SLR-69-13

## UNECE R48

Standard rear lamp on the market

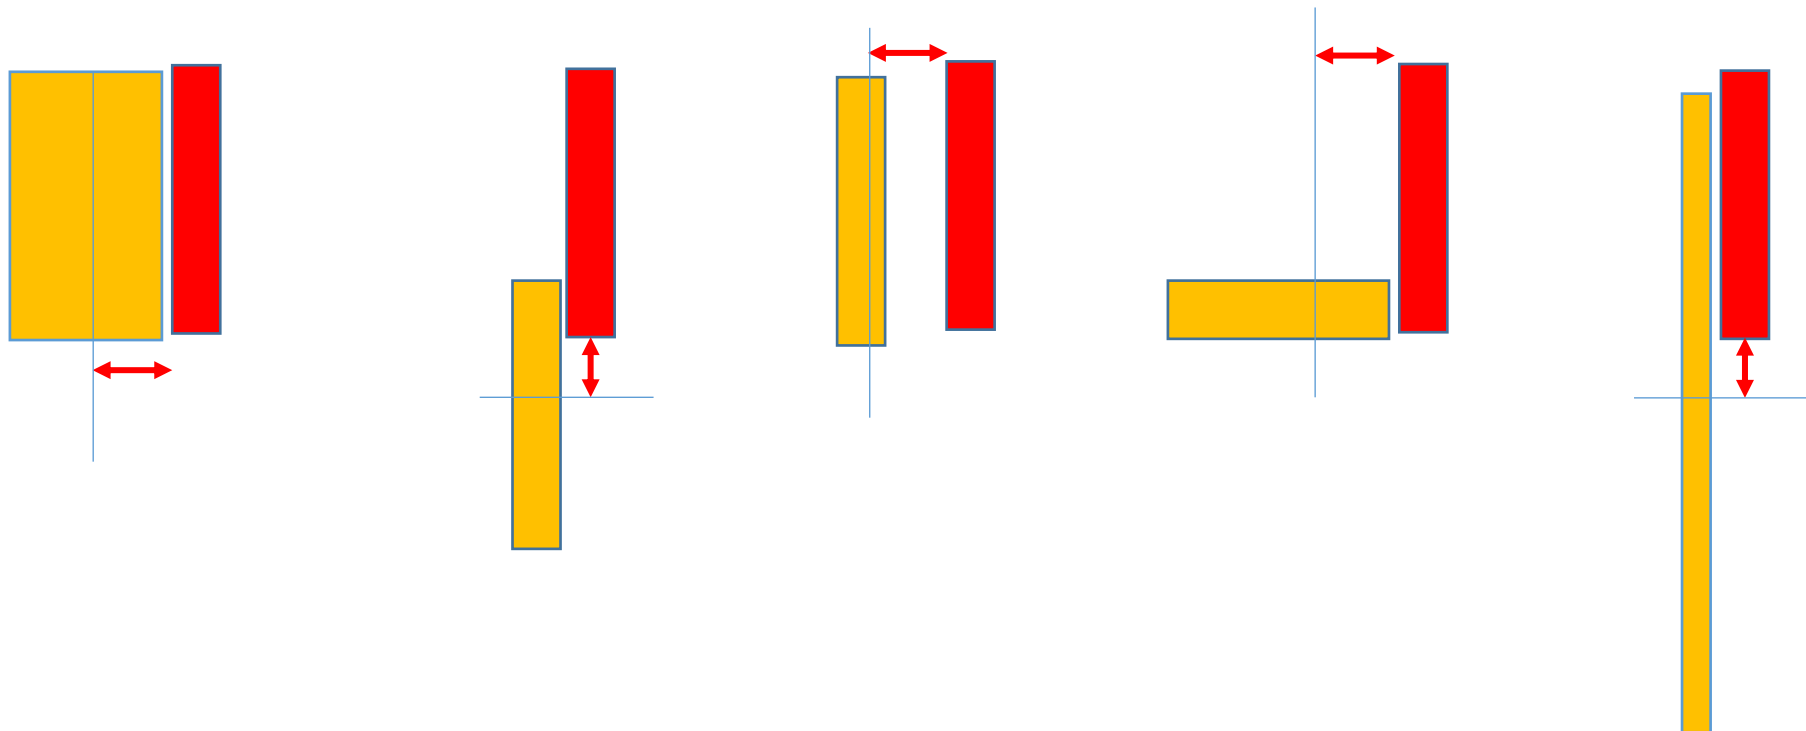
Problem:  
visibility of the D.I.  
when the STOP is "ON"  
(see video presented by Germany)

Solution : Minimum 50% of the D.I. apparent surface at more than 25 mm from the STOP

A minimum of 50% of the apparent surface of the rear direction-indicator lamps (category 2a or 2b) shall be at mote than 25mm from the stop lamp.

Justification: Existing solution without problem for the D.I. visibility when the STOP is "ON" should not be cancelled (minimum 50% of the D.I. apparent surface at more than 25 mm from the STOP )
